Drain: KINGSBOROUGH DRAIN **Drain #:** 297
Improvement/Arm: KINGSBOROUGH - SECTION 3
Operator: SLM/JOH **Date:** 1-9-04
Drain Classification: Urban/Rural **Year Installed:** 1998

RE: Kingsborough Drain, Section 3 arm

Re: Kingsborough Drain: Sec. 3 Arm

SITE DEVELOPMENT PLAN
 KINGSBOROUGH SECTION THREE
 CARMEL INDIANA

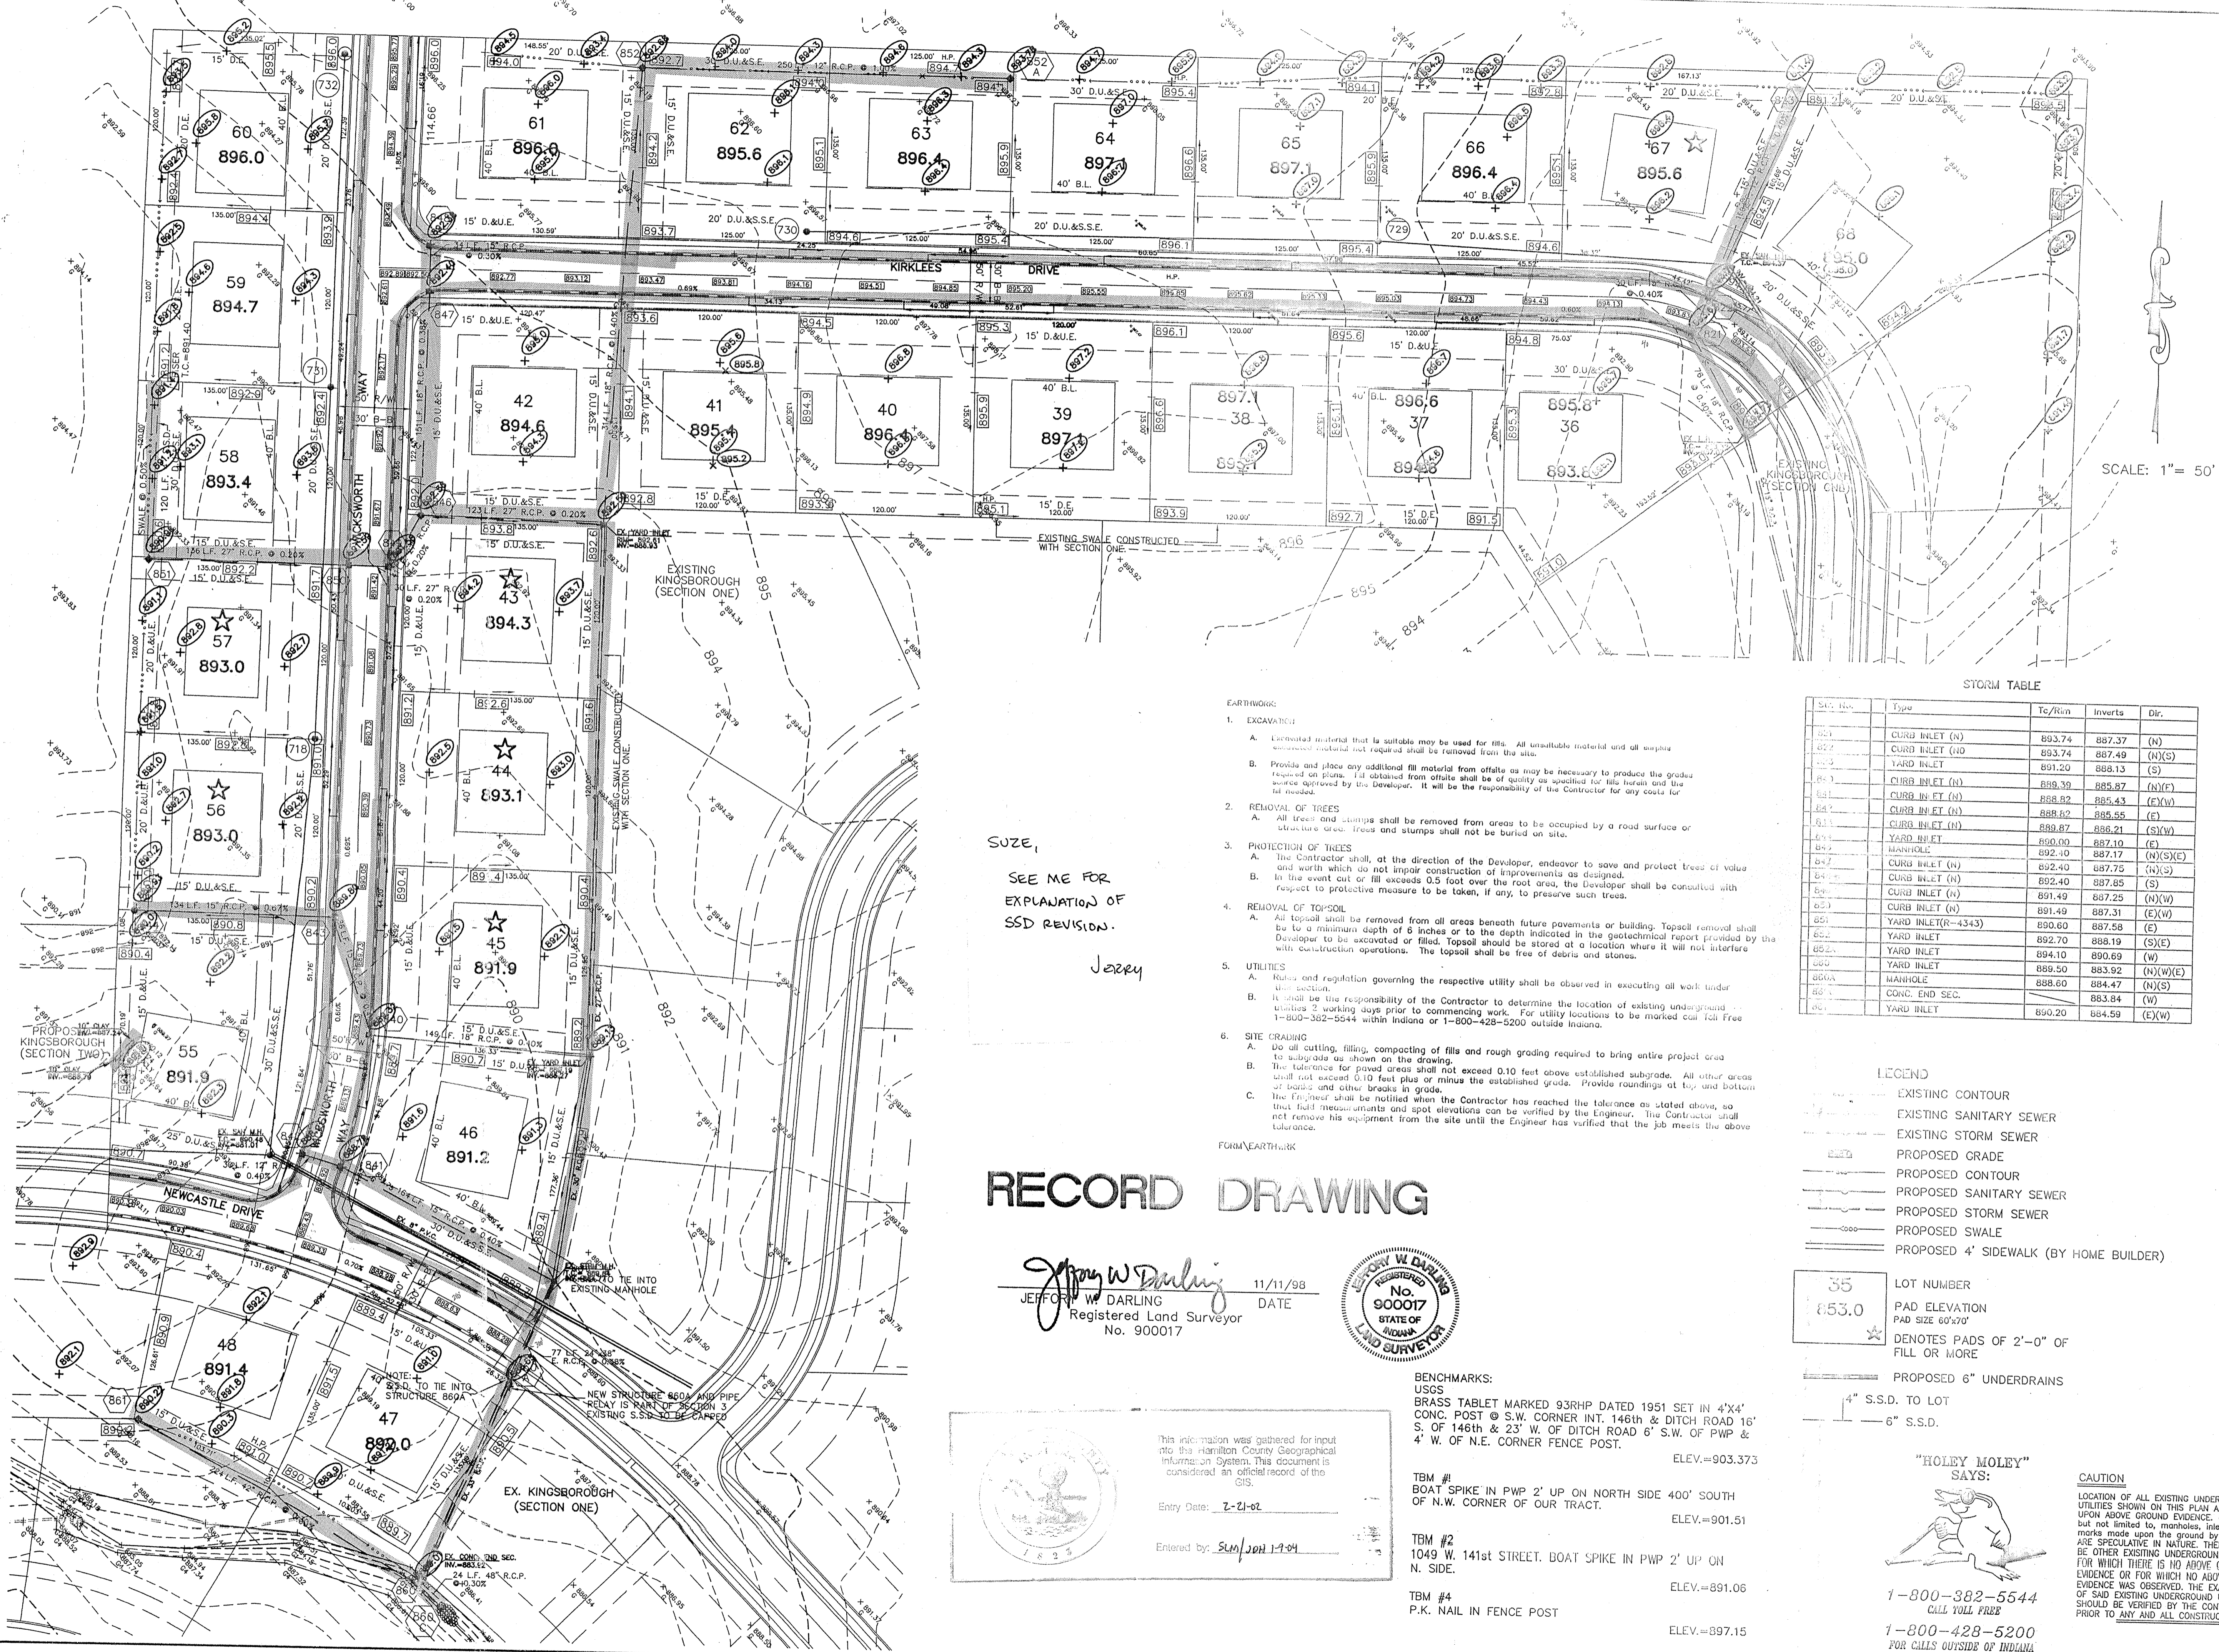
SEE ME FOR EXPLANATION OF SSD REVISION.
 Jerry
